Regulation No. XXX

UNIFORM PROVISIONS CONCERNING THE APPROVAL OF
I EMERGENCY CALL DEVICES (AECD)
II VEHICLES WITH REGARD TO THE INSTALLATION OF AN
AECD OF AN APPROVED TYPE
III VEHICLES WITH REGARD TO THEIR AECS

Preliminary comments from the Secretary of GRSG informal group on AECS

2. This document is an attempt to show the status of the discussions after the 9th meeting of the informal group. The changes compared to AECS-02-02-Rev.4 (status after 8th meeting) are indicated in bold and strikethrough characters, save for Part III for ease of reading and because it was not discussed at AECS-09.

Figure 4 ~~Diagram of path calibration~~

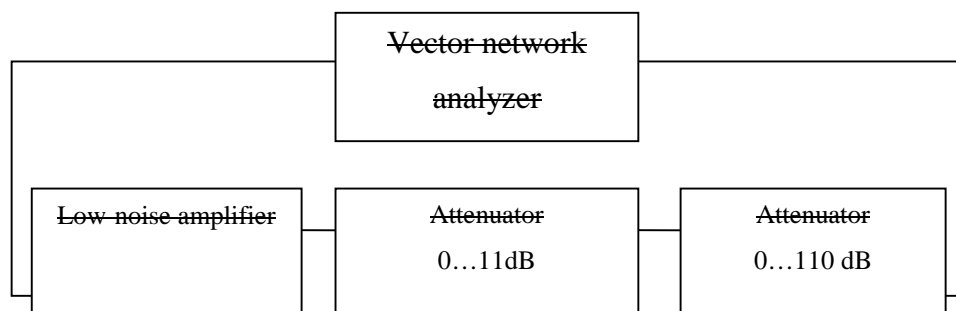
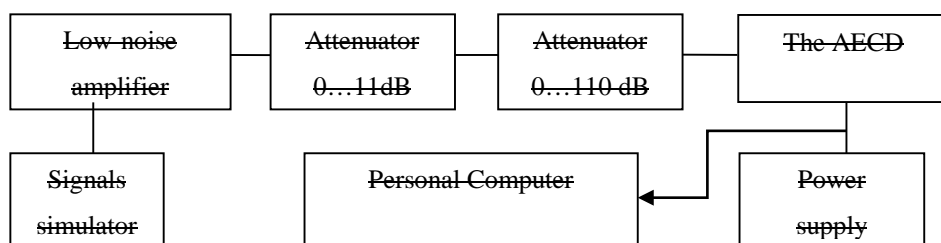
- ~~3.7 Test of navigation receiver sensitivity in cold start mode, tracking mode, and re-acquisition scenario.~~
- 3.7.1 ~~Turn on the vector network analyser. Calibrate the network vector analyser according to its operational manual.~~

3.7.2 ~~Set up the diagram according to Figure 4.~~

- 3.7.2 ~~Set zero signal path attenuation on attenuators. Measure the frequency response for a given signal path in the L1/E1 band of GNSS GLONASS/Galileo/GPS. Record the average path transmission factor in [dB] in this frequency band.~~
- 3.7.3 ~~Assemble the circuit shown in Figure 5.~~
